**ZONING AMENDMENT
PLANNED UNIT DEVELOPMENT &
SUBDIVISION STAFF REPORT**

Bostic Development at South Alabama, LLC
(Daniel L. Murray, Agent)

Case ZON2004-00679, -00682, & SUB2004-00179

SITE PLAN

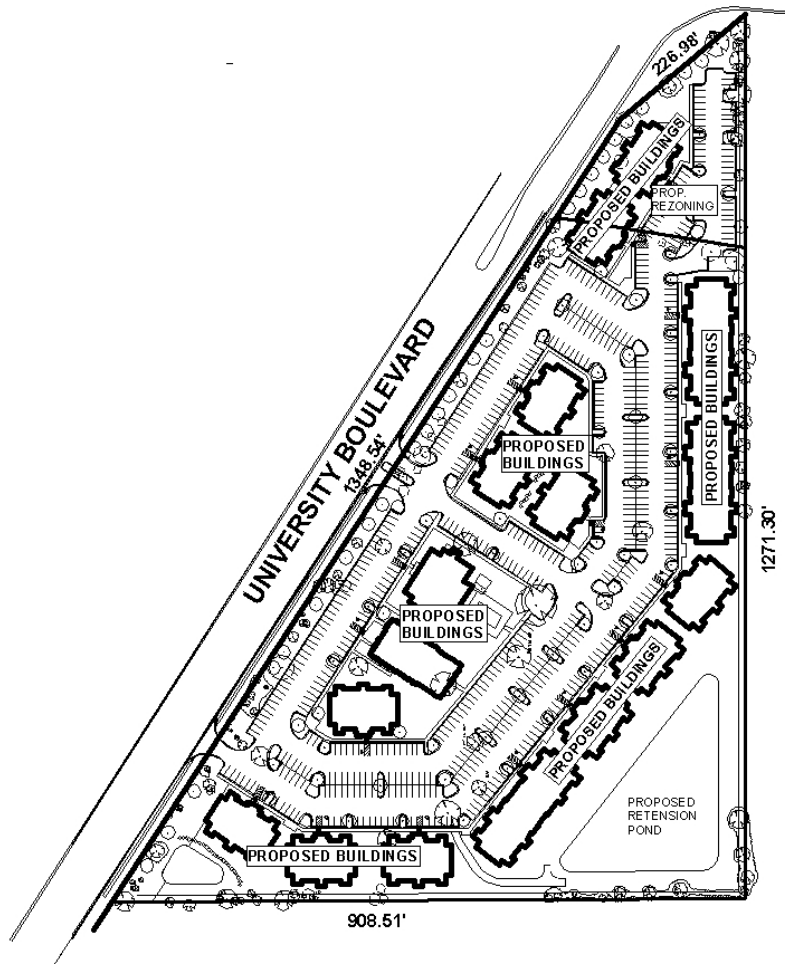
The applicant should dedicate a drainage easement
that can properly accommodate all stormwater drainage that enters the property from the
south. The current layout does not appear to allow for proper handling of stormwater.
Must comply with all stormwater and flood control ordinances. Any work performed in
the right of way will require a right of way permit.

While the site adjoins single-family residential development and a 15-foot buffer is provided along the East property line, and a 20-foot buffer is provided along the south property line, when the larger tract of property (the remaining 13 acres) was rezoned to R-3 in 1973, there were conditions placed on that rezoning. Specific conditions included the provision of an eight-foot solid fence along the east and south property lines and the provision of a 20-foot green belt along the east line. The proposed plan shows only a 15-foot buffer along the East property line.

The site plan illustrates that some buildings will have only a 20-foot separation; the PUD Section of the Zoning Ordinance allows 20-foot between buildings; however, only one exterior wall could have windows.

In regard to the proposed subdivision, only two curb cuts are proposed to University Boulevard, which should provide adequate access management to the Major Street. Additionally, in order to eliminate split zoning, the plat should not be recorded until the rezoning process is complete.

Rezoning: Based upon the preceding, this application is recommended for approval subject to the following conditions: 1) limited to the accompanying PUD; 2) the provision of a minimum buffer separation as outlined in the PUD Section of Zoning Ordinance, and if necessary, the elimination of exterior windows; 3) full compliance with the landscaping and tree planting requirements of the Ordinance; 4) the provision of a sidewalk along University Boulevard; 5) that the site be limited to two curb cuts to University Boulevard, with the location and design to be approved by Traffic Engineering; 6) full compliance with City Engineering Comments (dedication of a drainage easement that can properly accommodate all stormwater drainage that enters the property from the south [current layout does not appear to allow for proper handling of stormwater]; compliance with all stormwater and flood control ordinances; any work performed in the right of way will require a right of way permit); 7) full compliance with Traffic Engineering Comments (driveway number, size, location, and design to be approved by Traffic Engineering and conform to AASHTO standards; standard two-directional driveways and driveways with two lanes accommodating left and right turn traffic be widened to twenty-four feet); 8) dedication of any necessary right-of-way to provide 50-feet from the centerline of University Boulevard, a planned major street; 9) provision of an eight-foot wooden privacy fence and a 20-foot buffer where the site adjoins R-1, Single-Family Residential properties; and 10) full compliance with all municipal codes and ordinances.

Planned Unit Development: Based upon the preceding, this application is recommended for approval subject to the following conditions: 1) the provision of a minimum buffer separation as outlined in the PUD Section of Zoning Ordinance, and if necessary, the elimination of exterior windows; 2) full compliance with the landscaping and tree planting requirements of the Ordinance; 3) the provision of a sidewalk along University Boulevard; 4) that the site be limited to two curb cuts to University Boulevard, with the location and design to be approved by Traffic Engineering; 5) full compliance with City Engineering Comments (dedication of a drainage easement that can properly accommodate all stormwater drainage that enters the property from the south [current layout does not appear to allow for proper handling of stormwater]; compliance with all stormwater and flood control ordinances; any work performed in the right of way will require a right of way permit); 6) full compliance with Traffic Engineering Comments (driveway number, size, location, and design to be approved by Traffic Engineering and conform to AASHTO standards; standard two-directional driveways and driveways with two lanes accommodating left and right turn traffic be widened to twenty-four feet); 7) dedication of any necessary right-of-way to provide 50-feet from the centerline of University Boulevard, a planned major street; 8) provision of an eight-foot wooden privacy fence and a 20-foot buffer where the site adjoins R-1, Single-Family Residential properties; and 9) full compliance with all municipal codes and ordinances.

Subdivision: The plat meets the minimum requirements of the Subdivision Regulations and is recommended Tentative Approval subject to the following conditions: 1) dedication of any necessary right-of-way to provide 50-feet from the centerline of University Boulevard; 2) placement of a note on the final plat stating that the site is limited to two curb cuts to University Boulevard, with the location and design approved by Traffic Engineering; 3) completion of the rezoning process prior to the recording of the final plat.
